DESIGN REVIEW & EXCELLENCE PANEL RESPONSE REPORT

14-16 MARSHALL AVE, 2-10 BERRY RD & 5-9 HOLDSWORTH AVE, ST LEONARDS

DEVELOPMENT APPLICATION

May 2023

PRINCIPLE 6 AMENITY

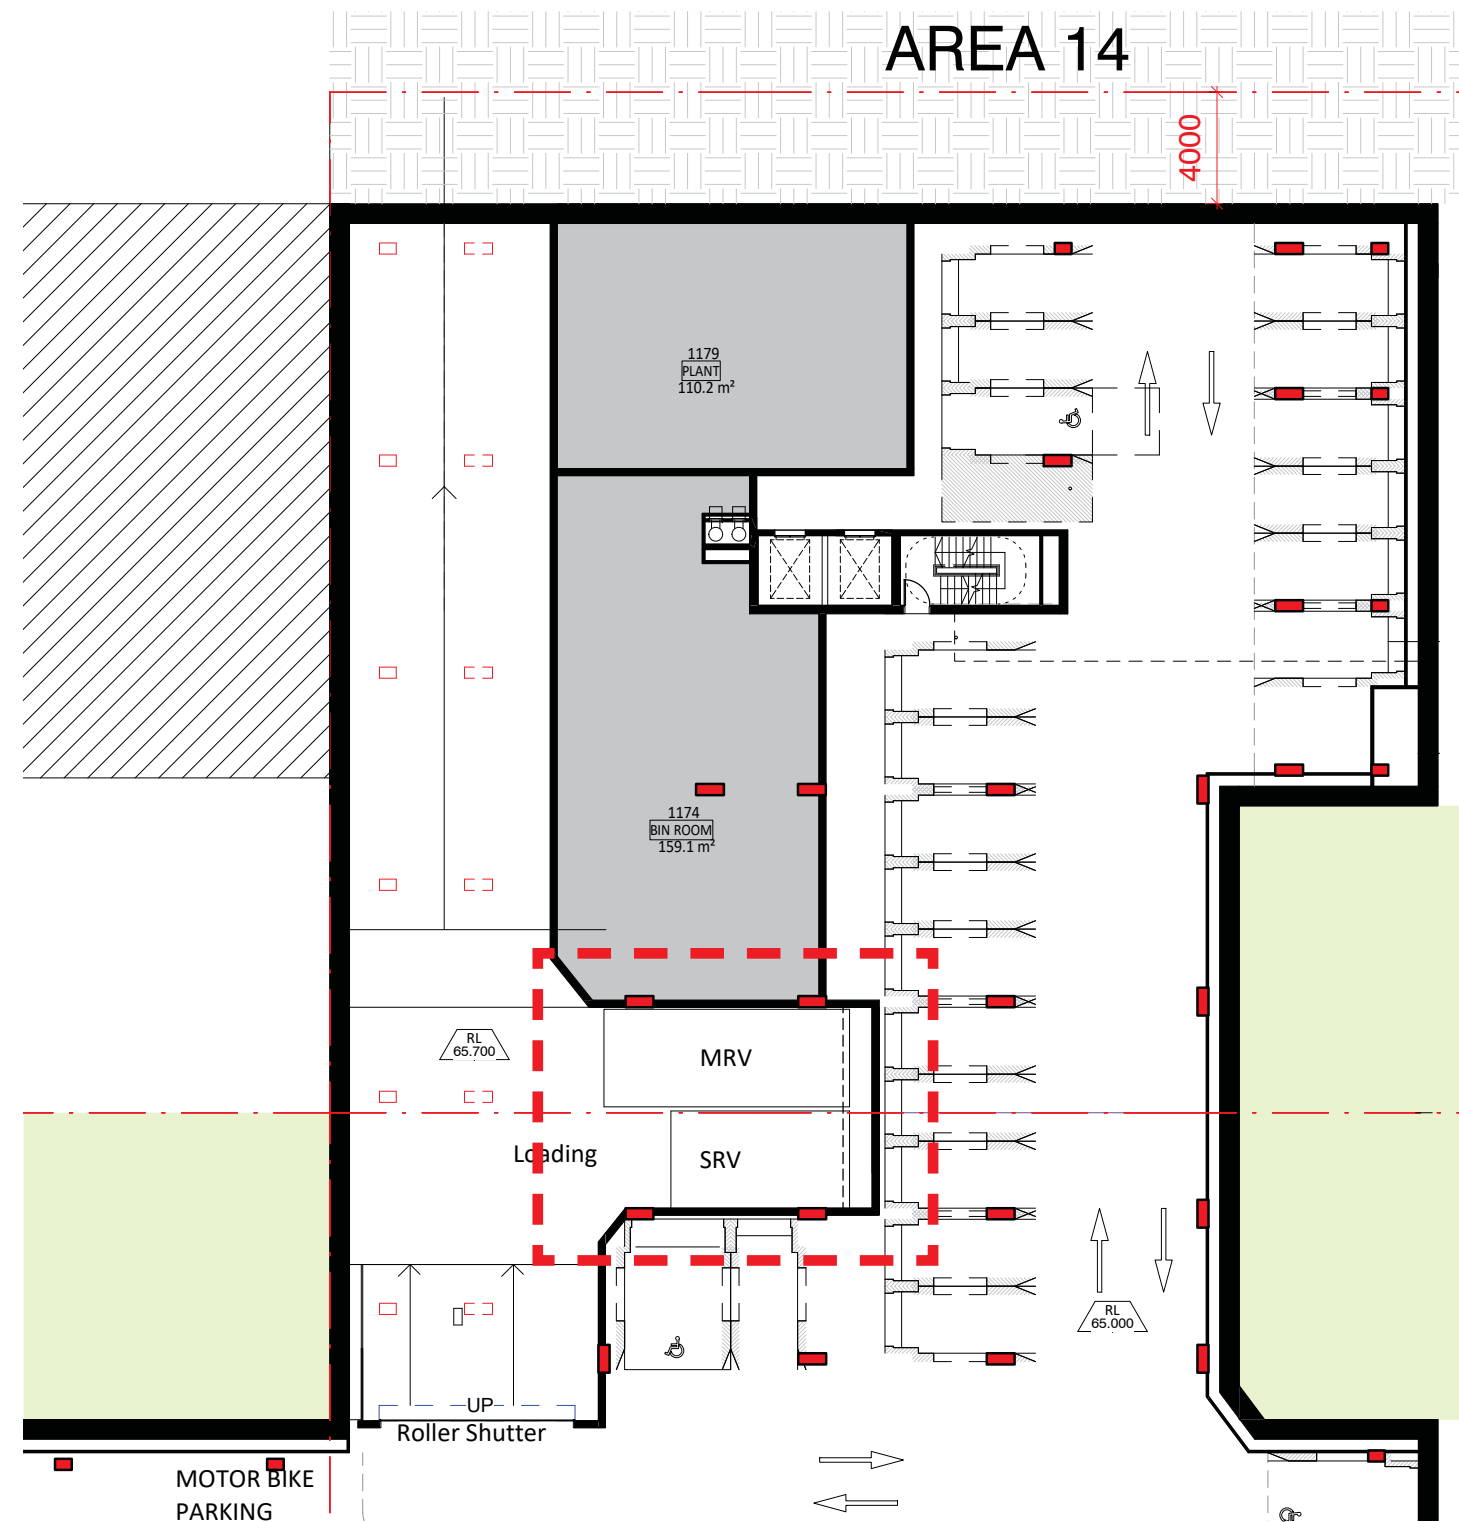
- REVISE LOADING DOCK TO ACCOMMODATE A LARGE WASTE VEHICLE (MRV OR HRV)

The proposal provides two truck bays including one MRV and one SRV.
